MODEL:  
7.6 BTD 60Hz / 5.7 BTD 50Hz  
6.5 BTD 50Hz / 5.0 BTD 50Hz

TOLERANCES (UNLESS OTHERWISE NOTED)		TITLE	
INCHES	MILLIMETERS	WIRING DIAGRAM / SCHEMATIC	
.XX	.09	DATE	8/June/91
.XXX	.005	APPROVED BY	
CAST	.03	SCALE	NONE
FINISH		SIZE	E
DIMENSIONS		DRAWING NUMBER	
(WHEN APPLICABLE)		39284	
		REV. H

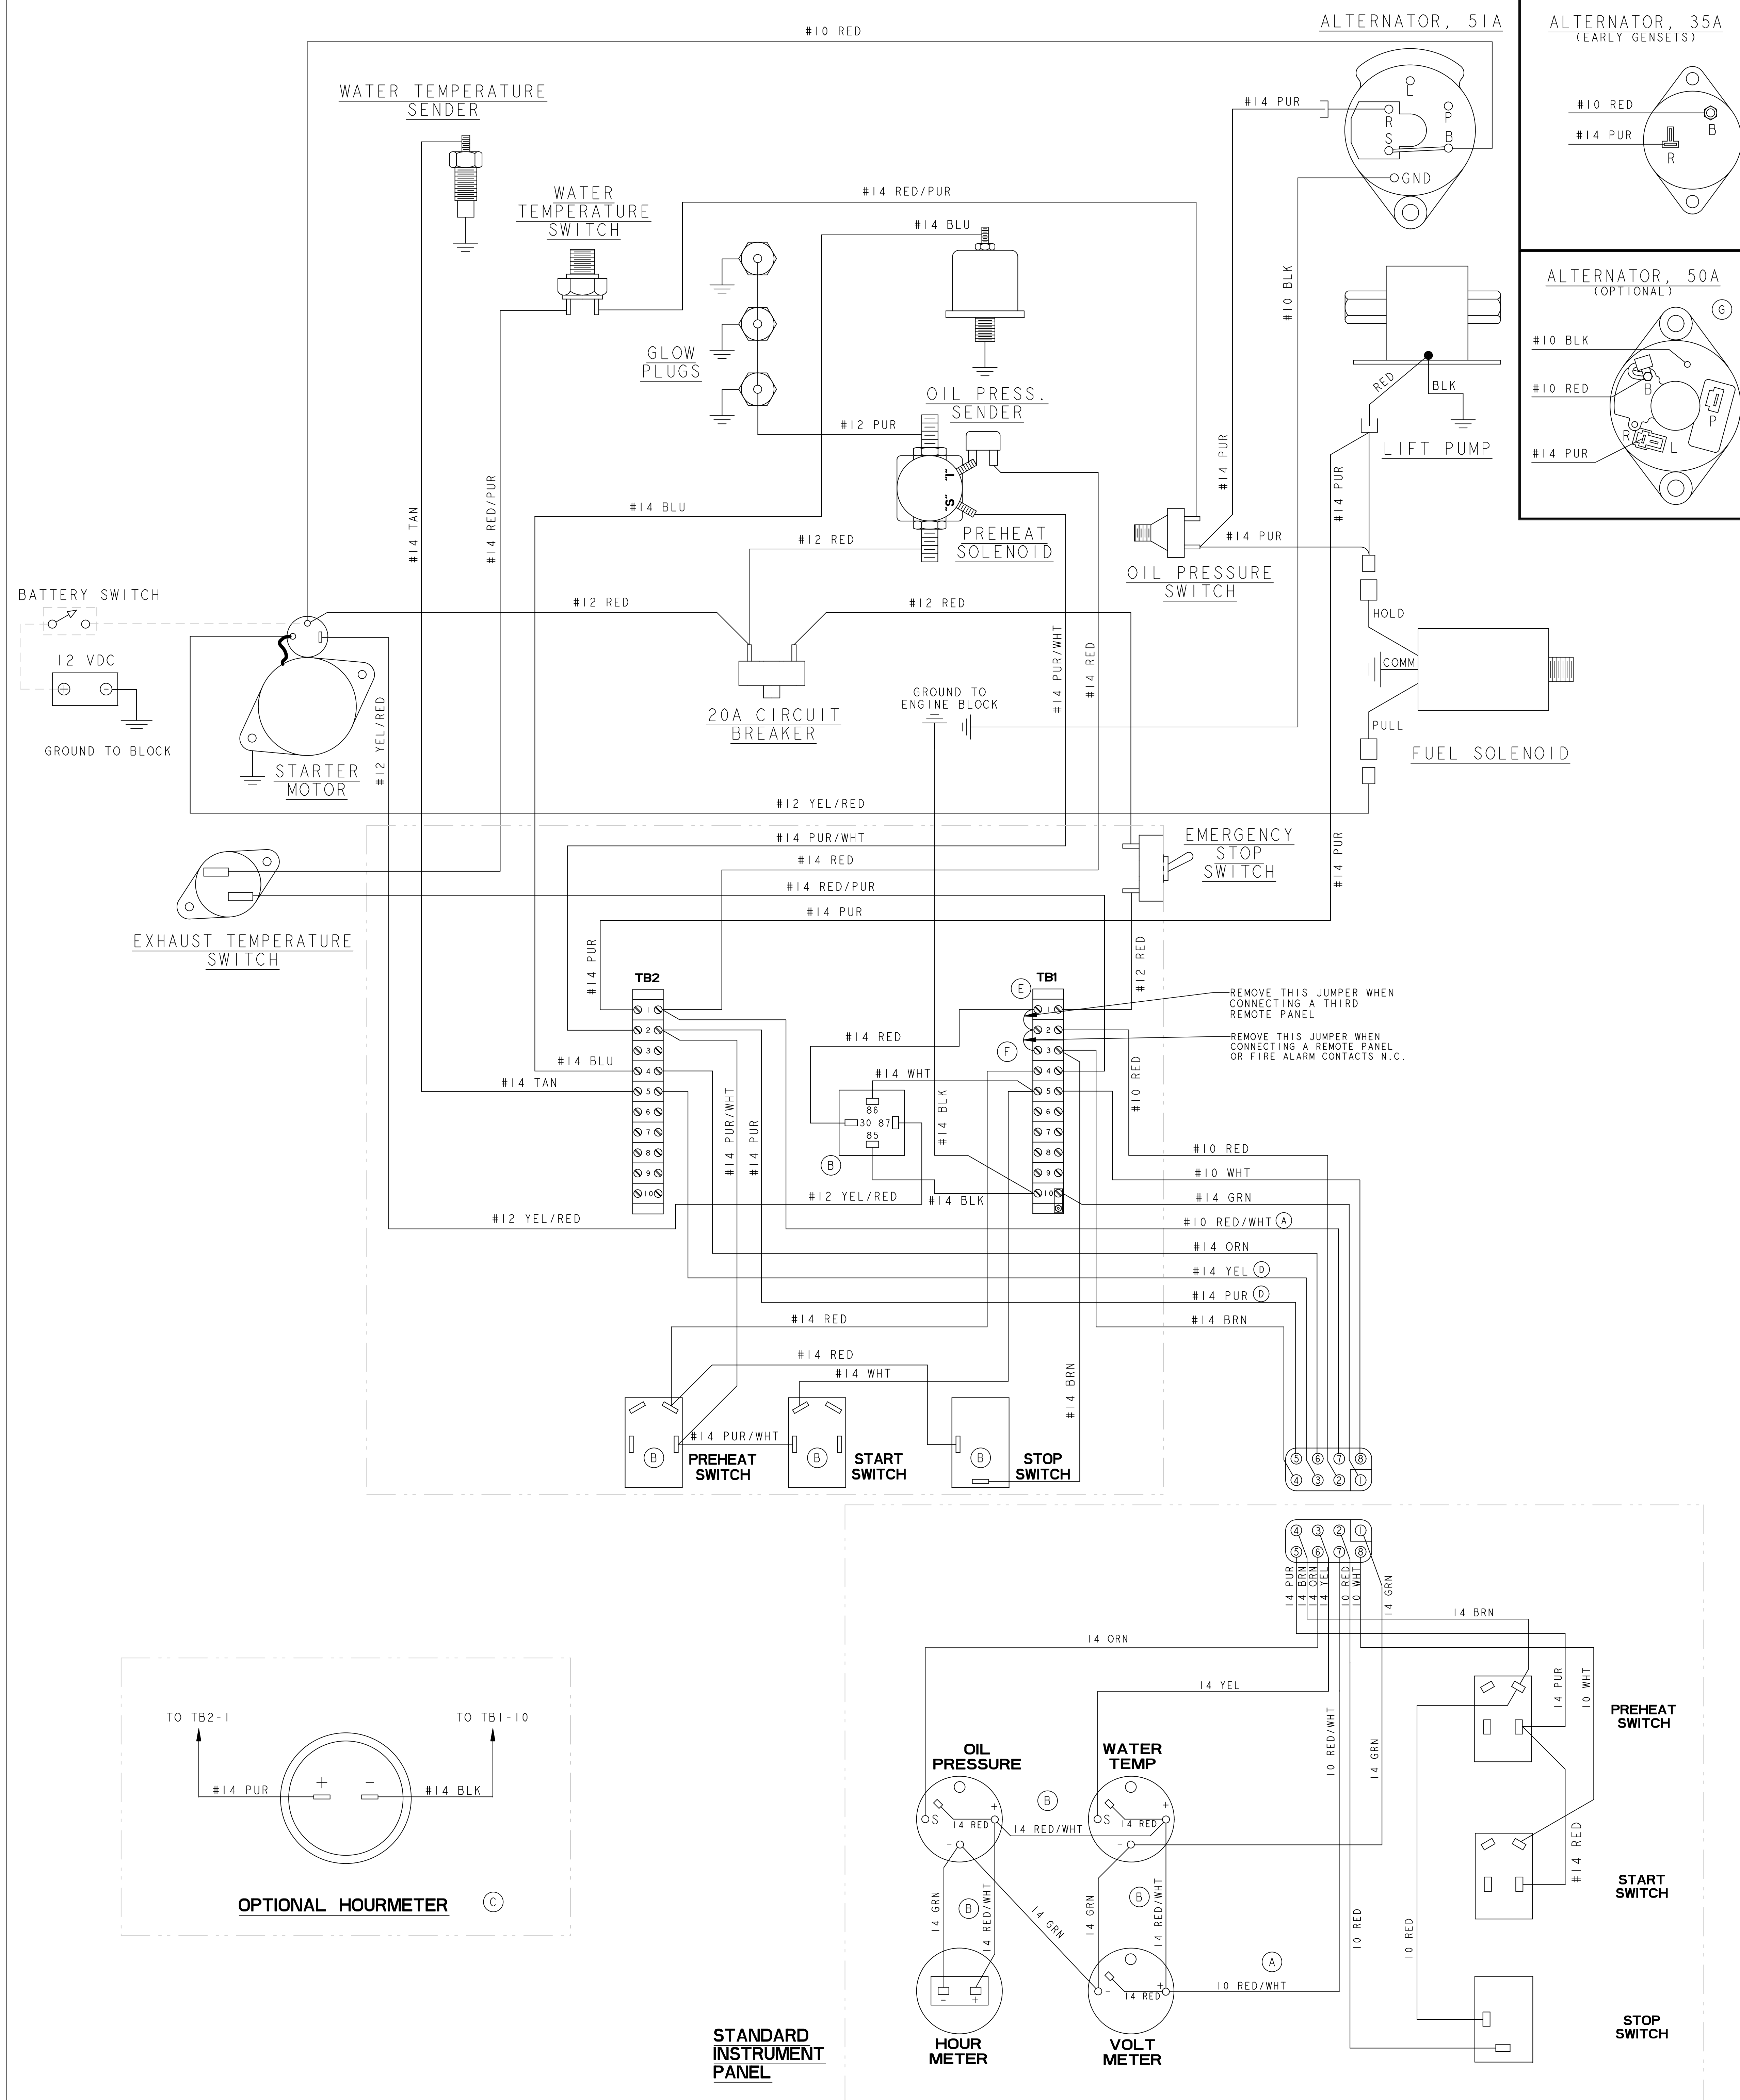
ECO NO.	DATE	REV.	REVISION RECORD	AUTH.	DR. BY
2444	7-26-94	A	CHANGED #10 BLACK WIRE TO #10 RED/WHT; OIL PRESSURE SWITCH WAS "CLOSED", NOW "OPEN"		JLN
2466	8-12-94	B	ADDED 3 SWITCHES (PREHEAT, START, STOP) TO CONTROL BOX; ADDED 5/1A ALT.; ADDED START RELAY TO CONTROL BOX; BLK. WIRES WERE GRN.; RED/WHT. WIRES WERE BLK.		WRM
2544	10-7-94	C	ADDED OPTIONAL HOURMETER DIAGRAM		WRM
2596	11-3-94	D	#14 PUR BETWEEN TB2 AND PANEL PLUG WAS #14 YEL; #14 YEL BETWEEN TB2 AND PANEL PLUG WAS #14 PUR		MKM
2863	11-27-95	E	ADDED TERMINAL REFS.; EXCHANGED POSITIONS OF JUMPER AND STOP SWITCH; PLUG 4 TO TB1-1 WAS TO TB1-2; PLUG 4 WAS TB1-3; TB1-3 WAS TO TB1-5; JUMPER FROM TB1-1 TO TB1-5 WAS FROM TB1-2 TO TB1-3		MRK
3193	2-10-97	F	ADDED JUMPER BETWEEN TB1-2 AND TB1-3; #14 RED TO TB1-4 WAS TB1-3; #14 WHT TO TB1-5 WAS TB1-2; #10 RED TO TB1-2 WAS TB1-4; #14 GRN TO TB1-3 WAS TB1-5; #10 WHT TO TB1-5 WAS TB1-4; #14 PUR TO TB1-2; PLUG 4 TO TB1-3; ADDED THIRD REMOTE PANEL NOTE.		MRK

4371	3-13-2000	G	ADDED OPTIONAL ALTERNATOR		JCA
7077	7-7-2014	H	ADDED MODEL 6.5/5.0 BTD		GA
